Technical Service Bulletin

66 Rear spoiler is inoperative

66 22 85 2065220/2 March 10, 2022. Supersedes Technical Service Bulletin Group 66 number 21-79 dated December 7, 2021 for reasons listed below.

Figure 1. Message in the driver's information system.

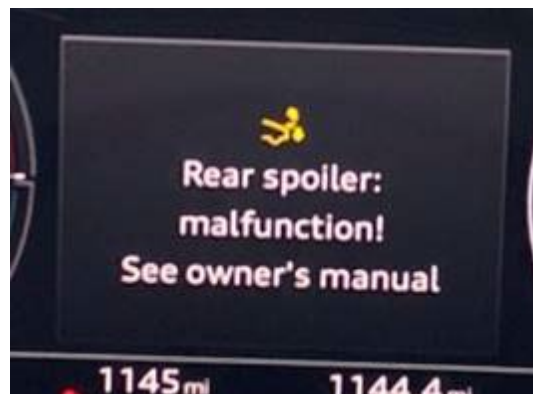
- The message “Rear spoiler: Malfunction!” appears in the driver’s information system (DIS) of the instrument cluster (Figure 1)
- Rear spoiler operation may not be possible.

Figure 2. Cutaway view of the motor brush to commutator area.

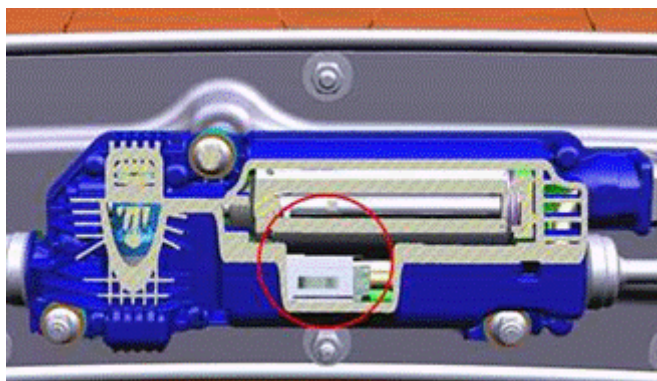
Due to insufficient pressure of the carbon brushes to the motor commutator in the spoiler drive motor a loss of contact may occur and cause intermittent or permanent loss of spoiler operation.

Figure 2 shows the spoiler drive motor area of brush to commutator contact.

The rear spoiler drive motor has been redesigned. An increase in brush to commutator pressure has been implemented in production.

Figure 3. Rear spoiler drive assembly.

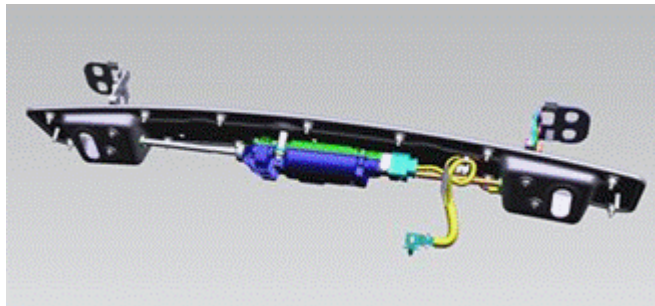
1. Should the vehicle exhibit the symptom profile described in this TSB, replace the rear spoiler drive unit. Figure 3 shows the rear spoiler drive assembly.

2. Complete the ODIS test plan and clear DTC(s).
